# **ACCESS 2022 A1 & SENIORS HOUSING INDICATIVE COMPLIANCE REPORT FOR DA LODGEMENT**

**82 Avalon Parade,  
Avalon Beach NSW 2107**

**Prepared for:** Element Environment Pty Ltd  
**Project No.:** PRO-09932-Q7H1  
**Date:** 24/07/2025  
**Status:** Report Issue v1.1

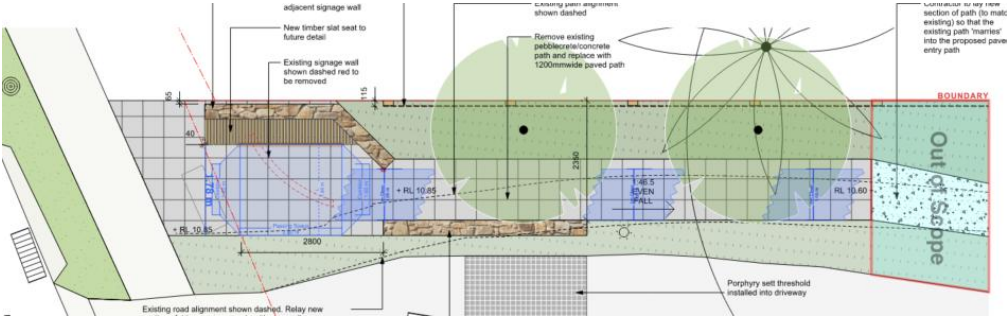
Siting standards		
Clause	Status	Clause Description
		<p>A continuous path of travel from the street frontage appears to be provided from street frontage, as illustrated below:</p>  <p><b>Ground Floor Level Access from Street Frontage</b></p> <p>Compliance with the Building Code of Australia indicates compliance with the requirements of this item.</p>
